Working Party on Automated/Autonomous and Connected Vehicles

Proposal for the 01 series of amendments to UN Regulation No. 130 (Lane Departure Warning System (LDWS))

Submitted by the expert from Australia*

Table 1

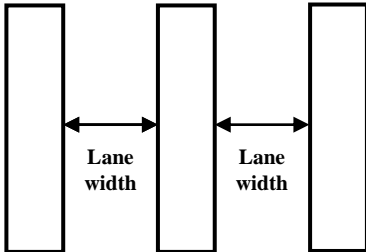
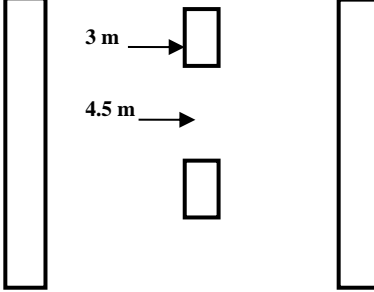
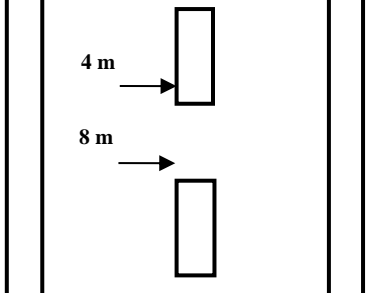
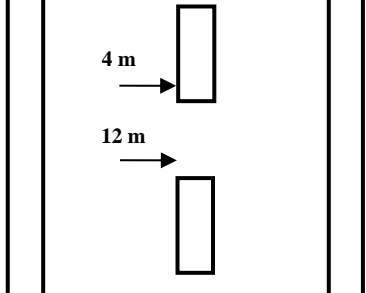
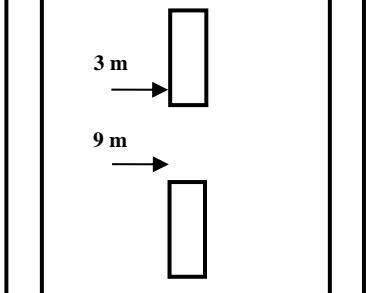
Pattern			Country	Width		
Left edge lane marking	Centre line	Right edge lane marking		Left edge lane marking	Centre line	Right edge lane marking
			Definition of lane width for the purpose of this Regulation			
			AUSTRALIA Two-lane, two-way road			
			AUSTRALIA Multi-lane undivided road

Pattern			Country	Width		
Left edge lane marking	Centre line	Right edge lane marking		Left edge lane marking	Centre line	Right edge lane marking
			Definition of lane width for the purpose of this Regulation			
			AUSTRALIA Two-lane, two-way road with lane changing allowed from one direction only	15 or 20 cm	10 cm 10 cm 10 cm	15 or 20 cm
			AUSTRALIA Two-lane, two-way road with lane changing not allowed	15 or 20 cm	10 cm 10 cm 10 cm	15 or 20 cm
			AUSTRALIA Single barrier line	15 or 20 cm	10 cm	15 or 20 cm
			CANADA

6. As this is a critical safety issue, Australia has included their local lane marking requirements into Annex 3 Table 1 of UN Regulation No. 130 and considers this amendment to be essential for ensuring the safety of vehicles that currently rely on these lane markings, as well as future vehicles that will also rely on these lane markings for steering and braking.

- (a) Detect edge line or outline markings of at least 15 cm thickness;
- (b) Detect variations in longitudinal gaps between lane markings ranging from a minimum of 3 m to a maximum of 9 m; and
- (c) Detect unique Australian barrier lines separated by a 10 cm lateral gap between the 10 cm thick dividing lines.
